Video8

B-mechanism know-how

8 MECHANISM DECK

Contents

Remedial measures when the trouble "T Reel Does Not Takes Up Tape " occurs (T reel caution)

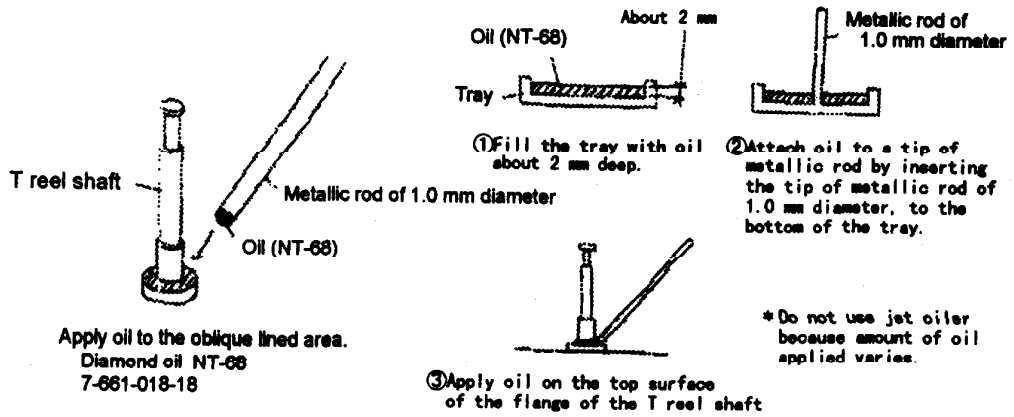
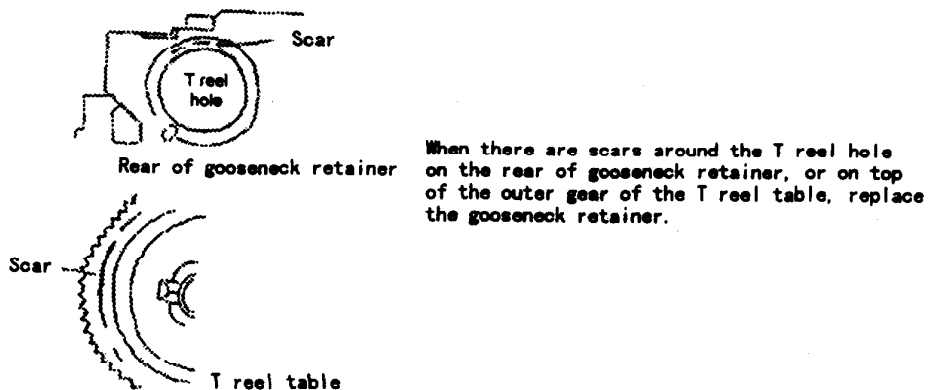
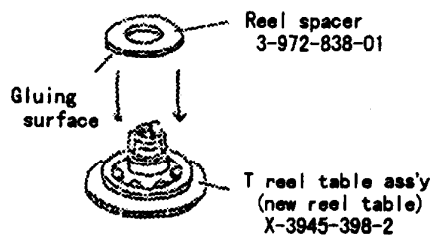
If the FWD torque (measuring T side torque during playback) using torque cassette, is 5 g-cm or less, there is a possibility that the take up torque becomes insufficient due to the torque loss between reel shaft and reel table. Apply oil to the T reel shaft as shown in Fig. 1.

When there are scars on the gooseneck retainer and T reel table as shown in Fig. 2, the gooseneck retainer interferes mechanically with the T reel due to bending of the gooseneck retainer. When there are scars, replace the gooseneck retainer.

When the trouble "T Reel Does Not Takes Up Tape " occurs in the cases other than the above describe items 1 and 2, add spacer to the T reel as shown in Fig. 3.

If tape slack occurs even though the FWD torque and gooseneck retainer are normal, it is anticipated that the T-reel height is low. Therefore, add one piece of reel spacer.

Remedy when grease is attached to tape

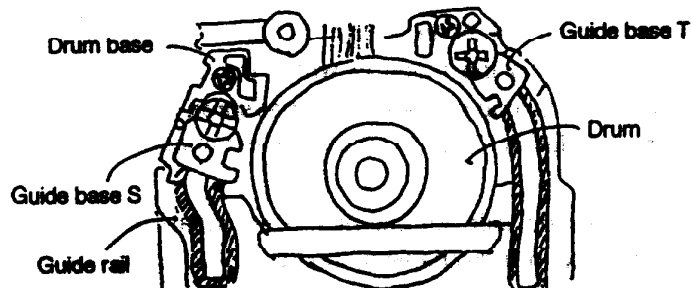
When grease which is oozed from type B mechanism of 8 mm, contacts tape, take the following remedy.

1. Remove grease (by wiping off grease using alcohol). The areas which must be wiped to remove grease, are shown below.

(1) Clean guide rail and guide base supply/takeup sliding surface of drum base using alcohol.

2. Grease is changed. (Changed to grease SG-941 which has small amount of ooze.)

Former		New
SG-055G (green)	→	SG-941 (blue)
7-651-000-09		7-662-001-39
